## Service Bulletin

No. : MZ04-035

**Model:** SR8300/SR9300

**Subject:** SETUP sometimes returns to initial setting.

1. Model Name is displayed like "SR9200", "SR8200", "PS9200:.
2. Software version of QU01(CPU) is displayed in the following format.

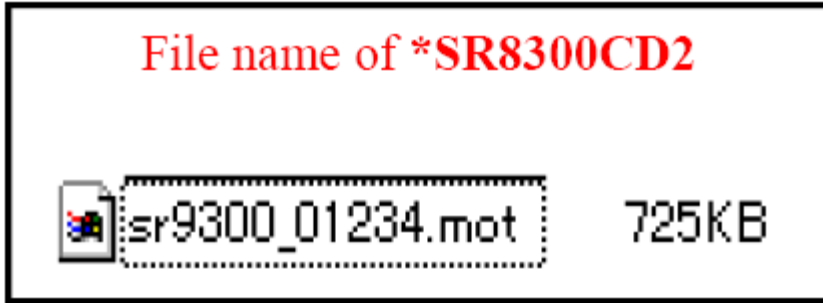
**Solution:** Update the CPU's software version to V0301234.

Note: before updating please check the CPU (QU01) firmware version. It can be confirmed using the "SERVICE PROGRAM", please refer to page 95 of the SR8200/SR9200 Service Manual for the procedure.

V030123 4
